October 6, 2021

Subject: RESPONSE TO REQUEST FOR ADDITIONAL INFORMATION FOR
REVISION 25 OF THE TRUPACT-II SHIPPING PACKAGE APPLICATION,
DOCKET NO. 71-9218, AND REVISION 8 OF THE HalfPACT SHIPPING
PACKAGE APPLICATION, DOCKET NO. 71-9279
(EPIDS L-2021-LLA-0033 AND L-2021-LLA-0034)

STRUCTURAL EVALUATION (St)

FIGURE 1 – HalfPACT Package with Two SC-55G1s; Shifted Point Source

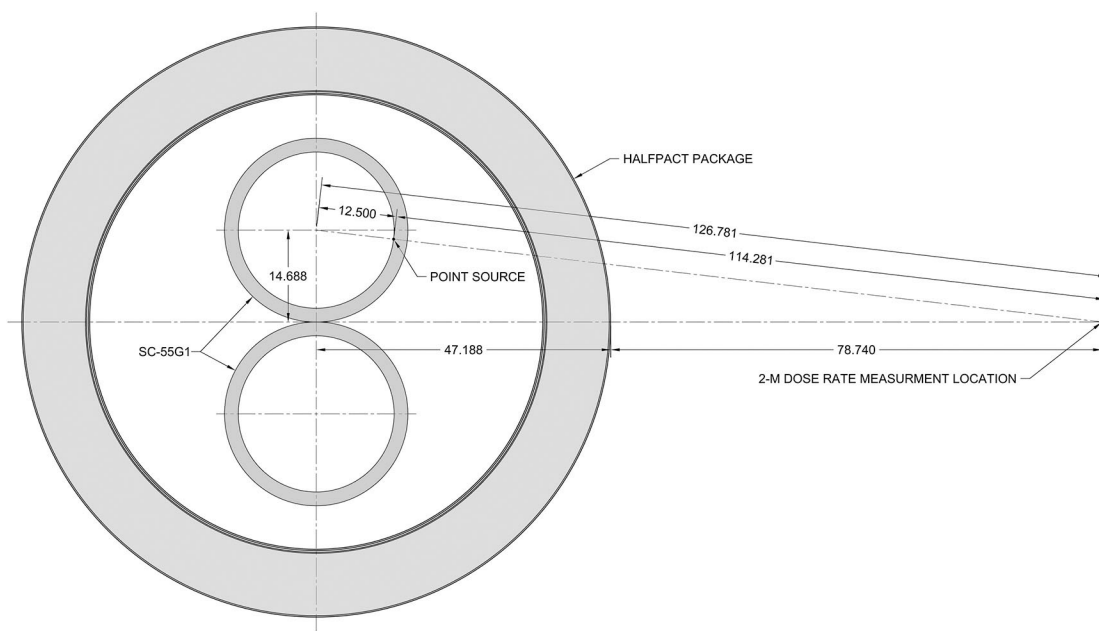
under NCT where the combined sum of partial fractions for gamma and neutron source terms are required to be less than or equal to 0.9. As shown below, potential reconfiguration of the source material in the shielded containers under NCT is highly improbable and will not cause a significant change in the limiting package dose rate values. Other potential sources of dose rate increase under NCT are not applicable for shielded containers due to test results indicating no damage to the payload container under those conditions.

Using distance attenuation for the SC-55G1 configuration as an example, where the dose rate is directly proportional to the inverse square of the distance, the limiting dose rate of 10 mrem/hr at a distance 2 meters from the HalfPACT package surface containing two SC-55G1s with initially centered point sources that are unrealistically moved the full radial distance to the SC-55G1's inner shell surface would only increase to $(126.781/114.281)^2 \times 10 = 12.3$ mrem/hr (see Figure 1). Similarly, the limiting dose rate of 10 mrem/hr at a distance 2 meters from the HalfPACT package surface containing one SC-55G2 with an initially centered point source that is unrealistically moved the full radial distance to the SC-55G2's inner shell surface would only increase to $(125.928/113.448)^2 \times 10 = 12.3$ mrem/hr (see Figure 2).
